FINAL ENVIRONMENTAL IMPACT STATEMENT REHABILITATION OF
LOCKS AND DAM NUMBER 1 MINNEAPOLIS MINNESOTA(U) CORPS
OF ENGINEERS ST PAUL MN ST PAUL DISTRICT JUL 78

FINAL
 ENVIRONMENTAL IMPACT STATEMENT
 REHABILITATION OF LOCKS AND DAM NO. 1
 MINNEAPOLIS, MINNESOTA

**LETTERS of COMMENT
and
CORPS RESPONSES**

Figure 7

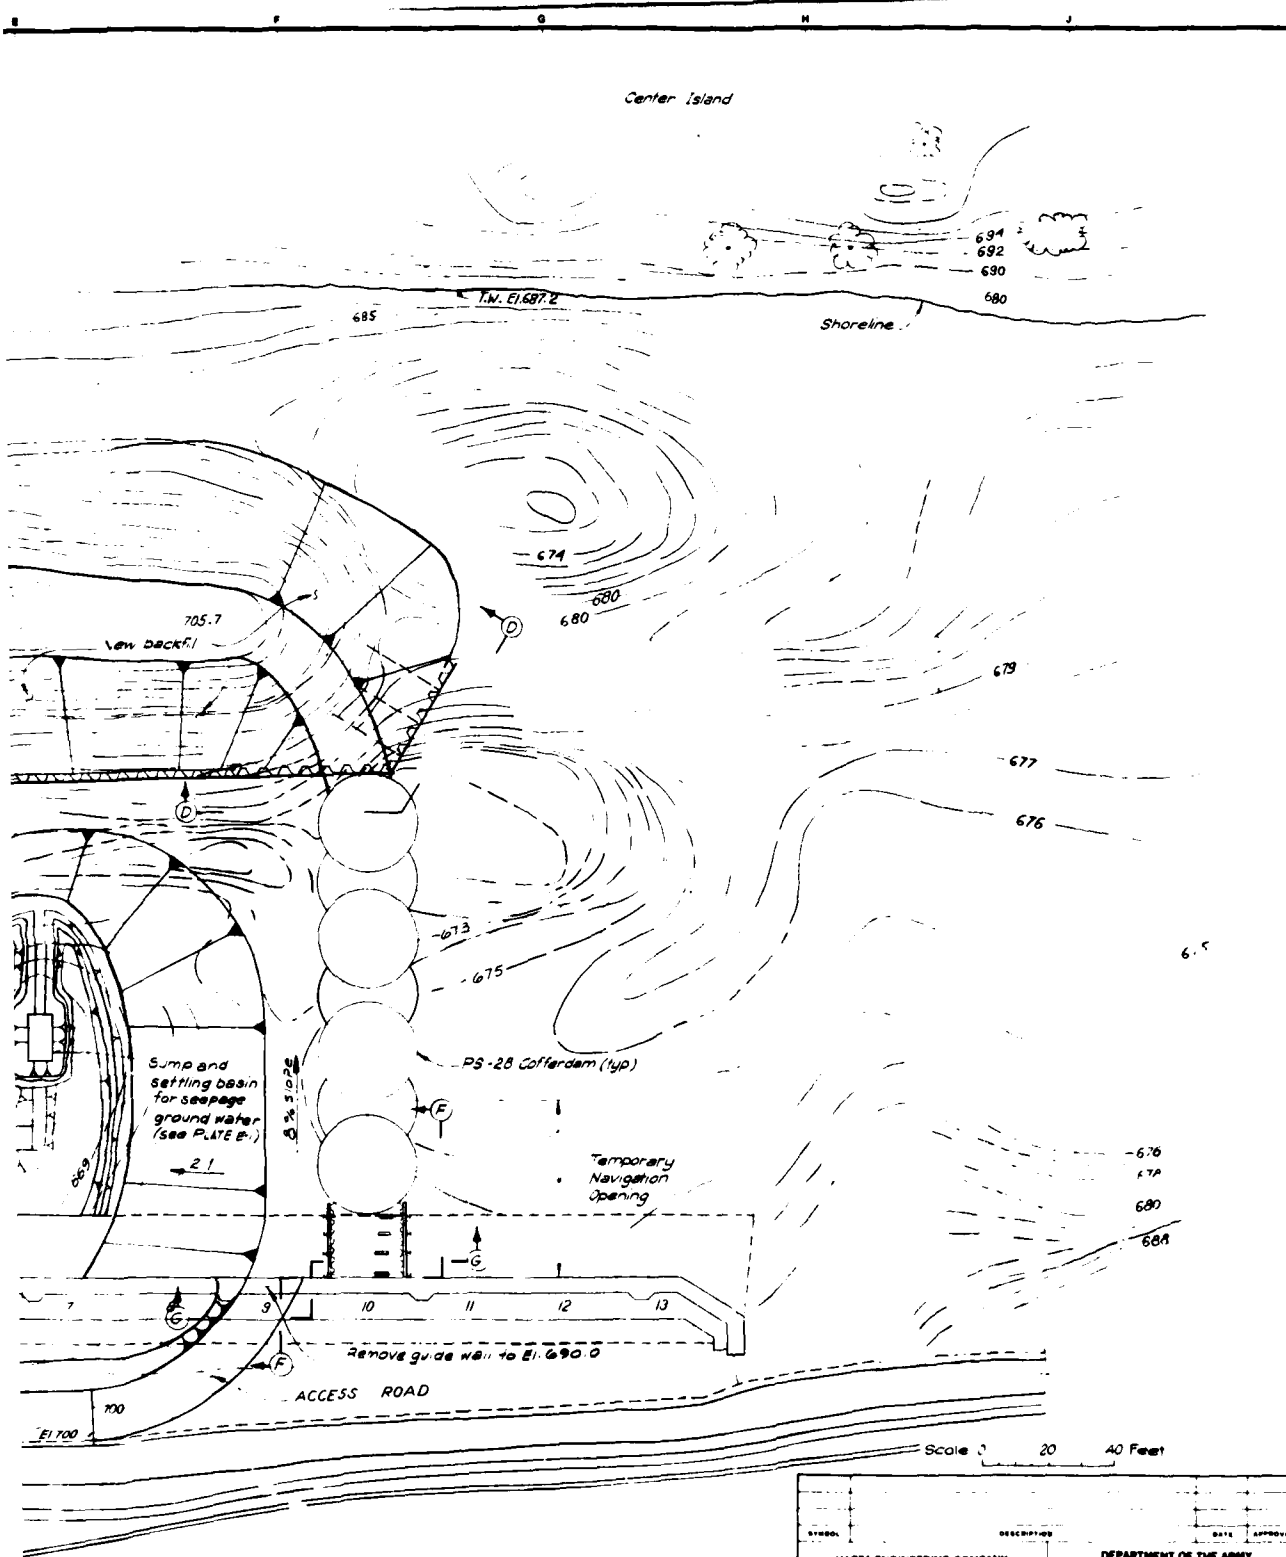
Page 12, Paragraph 1.17 - Cofferdam Construction --
It is noted that cofferdam sewage water would be pumped directly back into the river. However, figure 7 notes that a settling basin is in the project design. The narrative does not describe the settling basin or predict the degree of settling that is likely to occur. It is suggested the settling basin be further addressed in the final environmental statement

1. As now proposed, the project would not affect the island. The new location of the lower cofferdam is shown in Figure 7.

2. The conceptual design of the seepage and construction water disposal facilities is described in paragraphs 1.13 and 1.15 and shown in Figures 6 and 7. Detailed design of the facilities would be developed during the Plans and Specifications stage of the project. As noted earlier, the seepage water and construction waste water would be kept separate. The amount of settling is not known, but some would take place in both sumps. This material would be removed manually and disposed of.
